**Subject** Chief Engineer's Advisory Group (CEAG) direction: SH16 Brigham Creek inclusion of Median Barriers

# Value Option Assessment Form

To	Chief Engineers Advisory Group
Primary Author	s 9(2)(a)
Date	14/01/2025
Subject	Median wire rope barrier inclusion on SH16 Brigham Creek to Waimauku Stage 1 Out of
Document Refence and revision	Rev 1
Supporting Documents

Figure 2: Typical Cross Section Stage 1

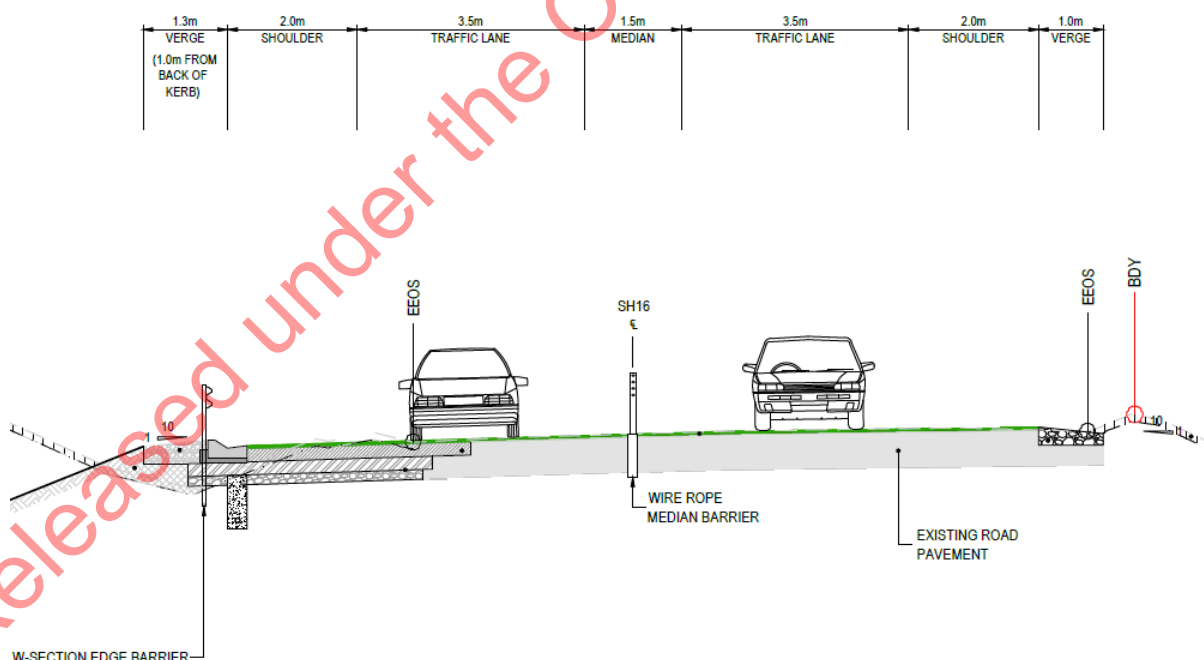
- 12.5m wide carriageway between edge of seals with a central wire-rope median barrier.
- 1.5m median with central wire rope barrier
- 2 x 3.5m lanes (one for each direction of travel)
- 2.0m outer shoulders. (increase safety for cyclists)
- Minimum edge protection w-section barrier.
- 1m (min.) Verge to be sealed (1st coat seal) to behind the barrier.
- The inclusion of the road safety barrier to safe guard the safe and appropriate speed of the route at 100km/hr. NZTA's view on this **may** have changed given the change in approach to the nation wide speed review program.

Due to the current 60% constructed status of stage 1 the main alternative would be to remove the wire rope barrier and replace this with a flush median.

<b>Alternative Option:</b> <i>(insert multiple options if comparing multiple)</i>	Remove 3070m median wire rope barrier throughout the stage 1 corridor.
<b>Description of Option</b>	<p>Removal of the central wire rope median barrier along length of the corridor. Wide flush median maintained. Typical carriageway will be made up of 2m shoulders, 3.5m lanes and 1.5m wide flush median.</p> <p>There could be an option to alter the typical cross section to 2.5m flush median and reduce the shoulder widths to 1.5m. This would need to be investigated.</p>
<b>Key Advantages</b>	<ul style="list-style-type: none"> <li>• Allows residents to conduct right hand turns into and out of their properties.</li> <li>• Minimal reduction in cost approx. \$260k.</li> <li>• Reduction in operation and maintenance costs.</li> </ul>
<b>Disadvantages</b>	<ul style="list-style-type: none"> <li>• Reduced road user safety improvements (DSI increase) with barrier removal. Some benefit from flush median estimated at a 50% reduction in DSI for this section compared to 66% for current design (based on 100kmh crash statistics)</li> <li>• Reduction of 3.5 or greater KiwiRAP star rated corridor by 1.6km.</li> <li>• Reputational damage. We have purchased property for and constructed four turning facilities that will be no longer required. This includes defending the project in the environmental court twice against the same landowner as part of the NoR and PWA process.</li> <li>• Installation of wire rope is under contract and we will need to remove it from the project scope.</li> </ul>

It is recommended that we continue with the current design and install the wire rope median barriers as planned.
